Access Compliance Report

Public Rights-of-Way

(Curb Ramps)

Intersection ID: 21723	Main Street: BALLENCOURT_LN	Cross Street: COLONY_RD	Location: NE
ADA ID: 71B4265E9F95	Ramp Type: PerpDiag	Initial Pass/Fail: Fail	Overall Compliance: No
Severity Score: 12.5			
Codes/Mitigation Info/Possible Solution		Field Measurements/Component Compliance

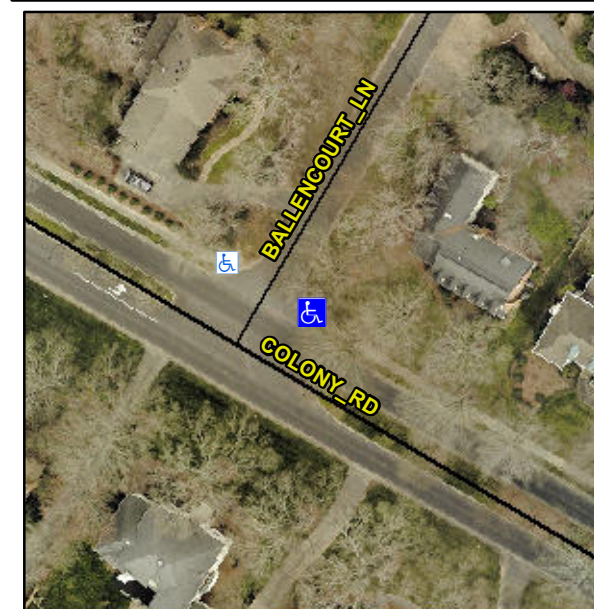
Not Found, R304.2.2

Compliance	Description	Data	Compliance	Description	Data
N/A	Ramp Length (in)	56.0	No	Ramp Slope (%)	9.6
Yes	Ramp Width (in)	48.0	Yes	Ramp XSlope (%)	1.2
N/A	Flare Type LT	N/A	N/A	Flare Type RT	N/A
N/A	Flare Slope LT (%)	N/A	N/A	Flare Slope RT (%)	N/A
N/A	Flare Traversable LT?	N/A	N/A	Flare Traversable RT?	N/A
N/A	Landing Length (in)	N/A	N/A	DWS Provided?	N/A
N/A	Landing Width (in)	N/A	N/A	DWS Contrast?	N/A
N/A	Landing Slope (%)	N/A	N/A	DWS Length (in)	N/A
N/A	Landing X Slope (%)	N/A	N/A	DWS Full Width?	N/A
N/A	Landing Curb? (Y/N)	N/A	N/A	DWS Offset (in)	N/A
N/A	Shared Landing?	N/A			
N/A	Gutter Ponding?	N/A	N/A	Gutter Slope (%)	N/A
N/A	Gutter Lip Ht (in)	N/A	N/A	Gutter X Slope (%)	N/A
N/A	Painted X Walk1?	No	N/A	Painted X Walk2?	No
	X Walk 1 Direction	To NW		X Walk 2 Direction	To SW
N/A	X Walk 1 Width (in)	N/A	N/A	X Walk 2 Width (in)	N/A
	X Walk 1 Slope (%)	0.6		X Walk 2 Slope (%)	3.3
	X Walk 1 X Slope (%)	5.5		X Walk 2 X Slope (%)	3.6

Remove & Replace Curb Ramp With Two New Directional Ramps or Equivalent.
